# SN J6802B-02A

## J6802B DNA MX

Line filter improperly wired in relation to fuses.

Photo #3

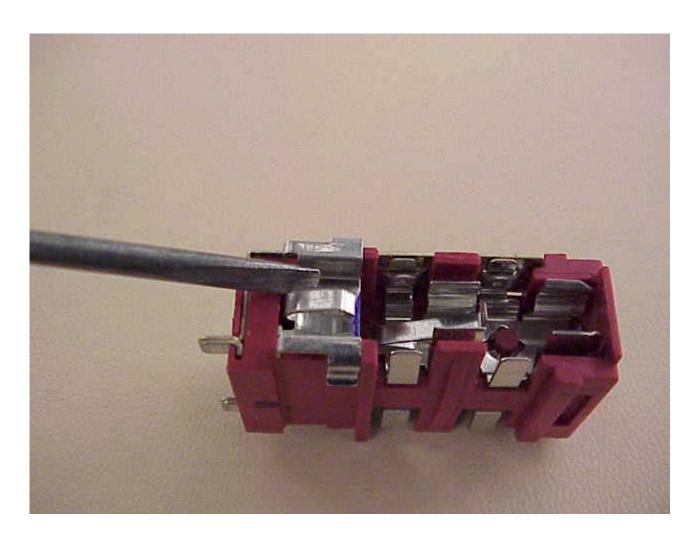
Do to an error in the assembly documentation the line filter was incorrectly wired on most of the first 150 units shipped. The fuse provides no protection for surges in AC line voltages to the power supply. This causes the power supply internal fuse to open and then the power supply ceases to function.

Remove shunt from fuse-block and replace with fuse. (See photos #3 & #4)
